**Staff Report
City of Richmond, Virginia**

Commission of Architectural Review

10. COA-128334-2023	Final Review Meeting Date: 4/25/2023
Applicant/Petitioner	Matson Roberts Jr., SMS Architects
Project Description	Various exterior alterations including a side addition, and rear and side second-story trellis.
Project Location	
Address: 2315 Monument	
Historic District: Monument Avenue	
<p>High-Level Details:</p> <ul style="list-style-type: none"> • construct a side addition, • install new garage doors, • install new lattice detailing on top of the rear and side faux wall, • remove a rear wood privacy fence and replace with a stucco wall and wood gate, • install a new door on the side elevation, • install trellage, • and install an outdoor staircase to the roof of the garage. 	<p>Staff Recommendation</p> <p>Approval, with Conditions</p>
Staff Contact	Samantha Lewis, Samantha.lewis@rva.gov , 804-646-5207
Previous Reviews	None.
Conditions for Approval	<ul style="list-style-type: none"> • Submit for administrative approval a simplified design for the shaped parapet façade on the addition. • Submit for administrative approval a paint color for the latticework to be installed. • Any new w

Figure 5. Decorative Gate located at 2309 Monument

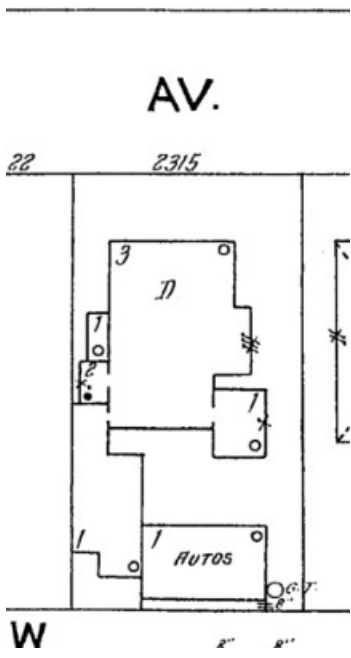
F. Treillage		
Standards for Site Improvements, p. 77, #12	<p><i>When considering the design of new fences, remember that some districts, such as Church Hill, historically featured some modest brick terraced areas in front yards, while some other districts, such as Monument Avenue and West Grace Street, historically did not. <u>In the event of a front yard landscaped area, the design should seek simplicity, rather than elaboration.</u></i></p> <p><i>Where physical or documentary evidence does not exist, the proposed front yard landscaped area should <u>be compatible in design, materials, and location,</u> and should look to precedent on the block face or the block face opposite, or within the district. ... Suitable design, materials, and location will vary by district. In any event, the non-historical over-development of front yards should be avoided.</i></p>	The treillage will be set back 28 feet from the street and front property line; about 9 feet back from the façade of the primary structure. The treillage also intends to be behind the existing trees on the site. Staff notes that this location is appropriate and will not disrupt the visual rhythm of the street. The gate associated with the treillage in the front/side yard will be quite ornate. On a site visit, Staff observed a few examples of decorative fences and gates.
